**SERVICE BULLETIN NO. 119****Error Codes 14 and 15**

**The following applies to oven models BPE, CPE and KPE:**

### Former connection:

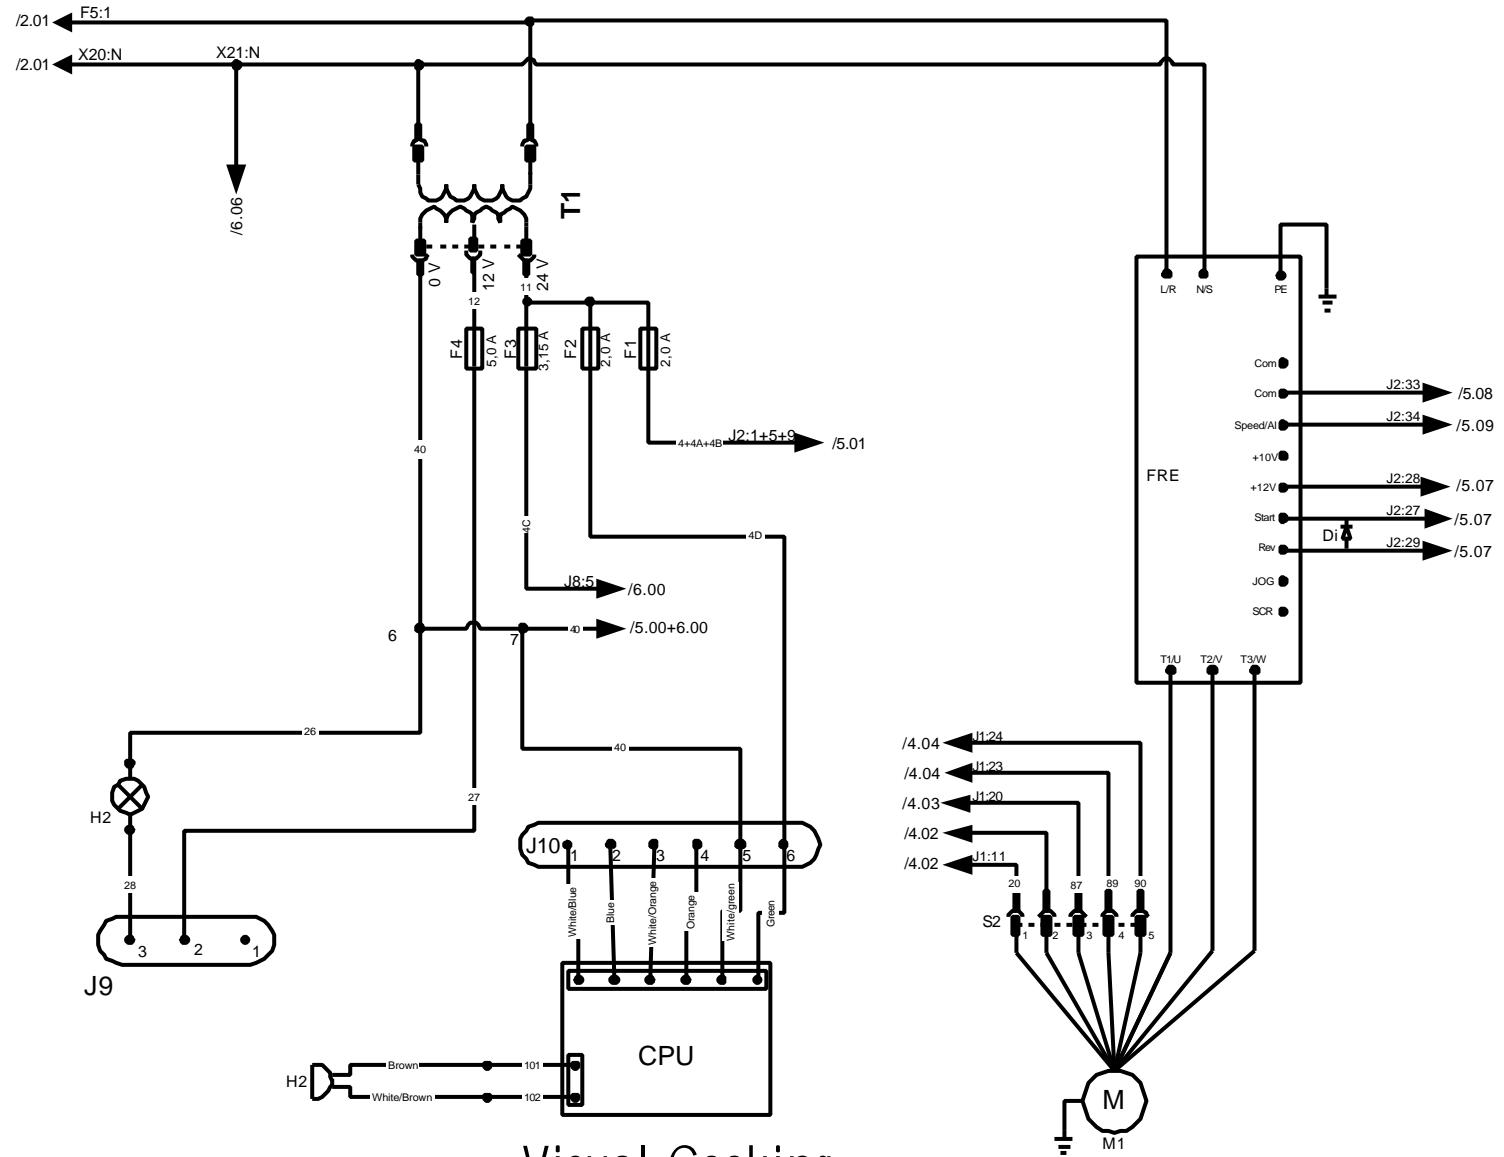
Error codes 14 and 15 also occur on oven models BPE, CPE and KPE. The fault can be remedied by proceeding as follows:

As it is, the frequency changer is directly connected to fuse F5. Disconnect the wire for the frequency changer and connect it to terminal 7 at main contactor K1. Then connect a wire from the output point of fuse F5 to terminal 8 at main contactor K1.
